# Reduction in $V_f$ (max) and Associated Parameters (Comments 345-360)

# Reduction in Vf Max and Associated Parameters

# Proposed Changes to Draft

# COM Simulations for CR

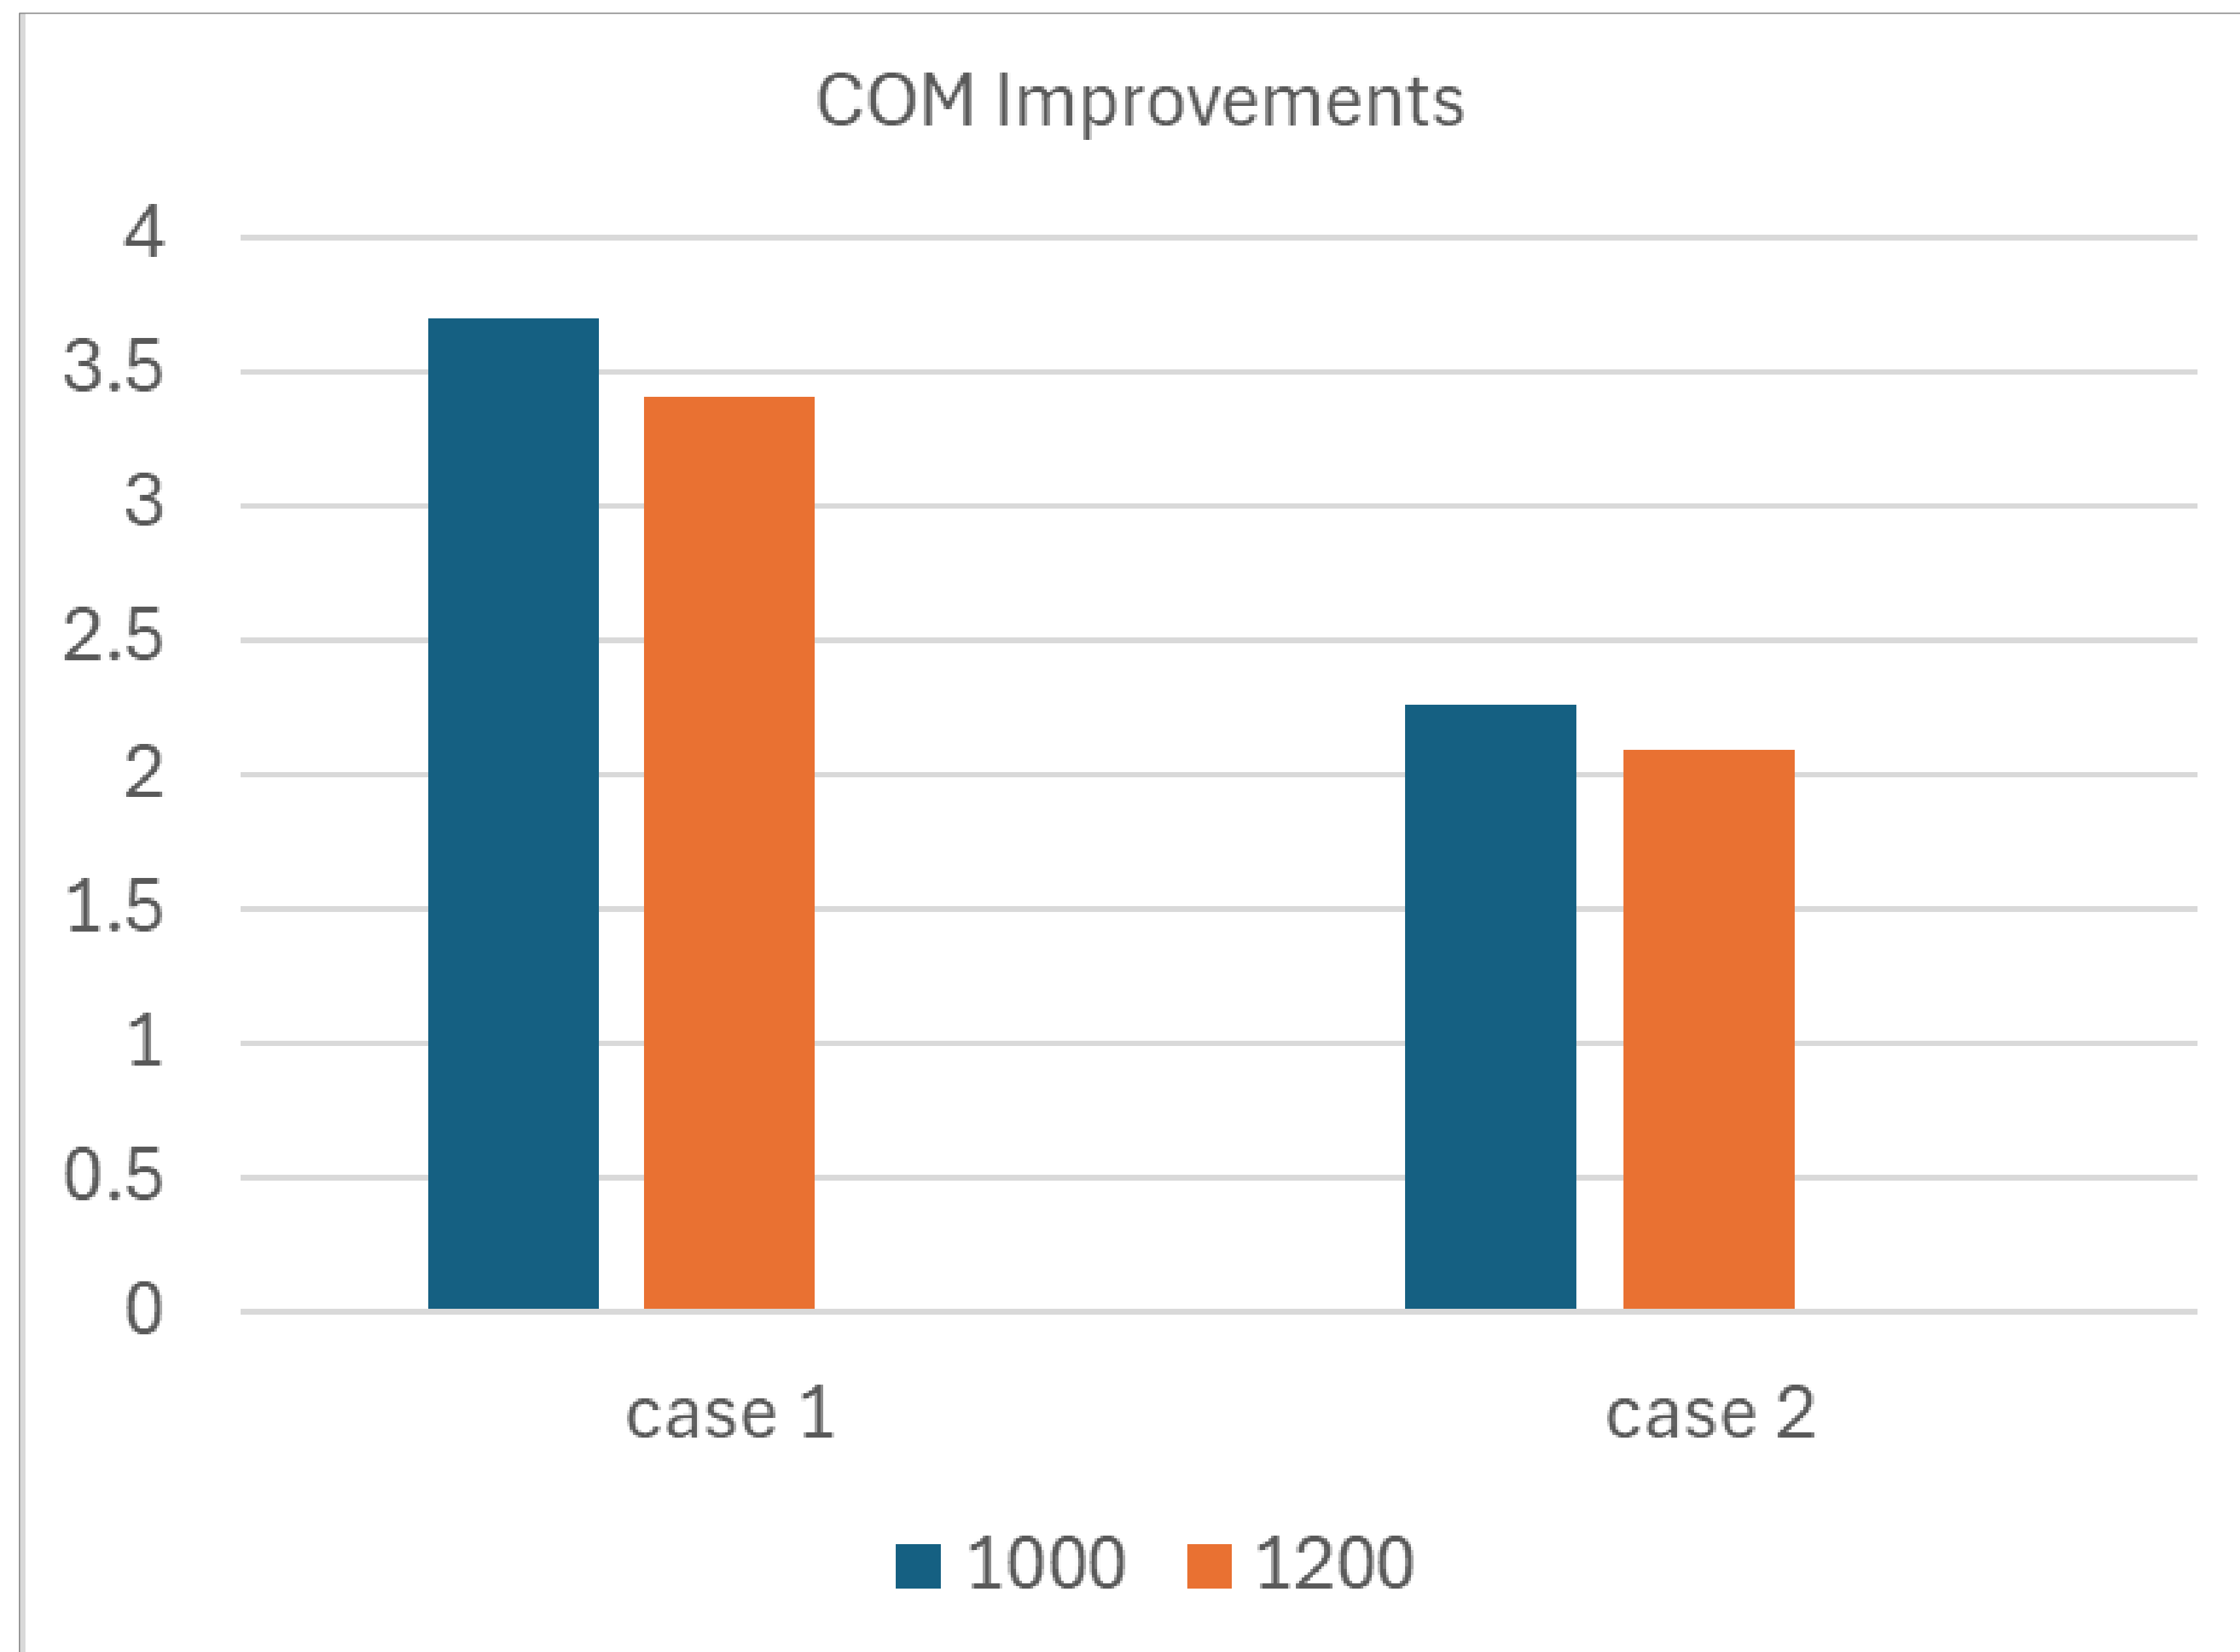
0.3dB and 0.17 dB COM improvements

- Example Case showing improvement of reducing the xtalk terms
- Simulations of marginal passing and marginal failing CR channels (Case 1 vs Case 2)
- Channels run with A<sub>ne</sub> .6V and then 0.5V mV
- Improvements noted in COM by reducing A<sub>ne</sub> relative to other parameters
- Further investigation may show additional improvements of other COM parameters
- This example:
  - uses akinwale\_3dj\_01\_2311, 22dB channel vendor X
  - COM4.6
